S E R V I C E N O T E

1660EP - 136 Channel Color Logic Analyzer with 32 Channel Pattern Generator

New Threshold Accuracy Field Calibration Procedure

3 Set up the Format menu.

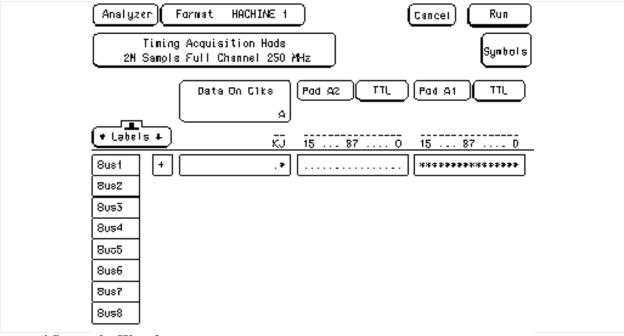
ADD the following steps to "Set up the logic analyzer" on page 3-10 of the 1660E,ES,EP-Series service manual:

- a. Press the Format key.
- b. Move the cursor over the Pod A1 channel selection field.

Press the Clear Entry button until all channels are assigned (all '*'), then press Done.
- c. Move the cursor over the Data on Clocks channel selection field, then press Select. Rotate the RPG knob to move the channel selector to the channel indicated in the following table, then press Select. Press Done.

Pod	Channel
A1, A3, A5, A7	0
A2, A4, A6, A8	1

2 Test the high-to-low transition.

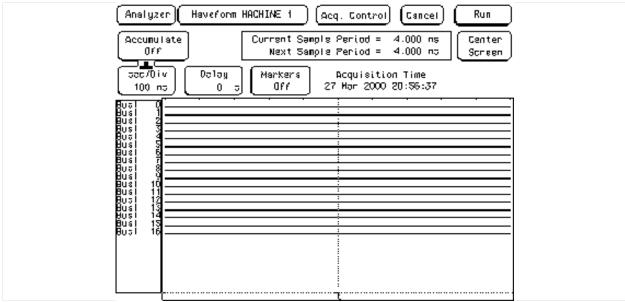
REPLACE pages 3-11 thru 3-17 with the following steps:

- a. On the DC power source, enter -1.438 V.
- b. On the multimeter, verify that the DC voltage is -1.439 V +0 mV, or -2 mV. Adjust the DC power source voltage output if necessary.
- c. On the logic analyzer, press Run. The display should show all channels at a logic "0".
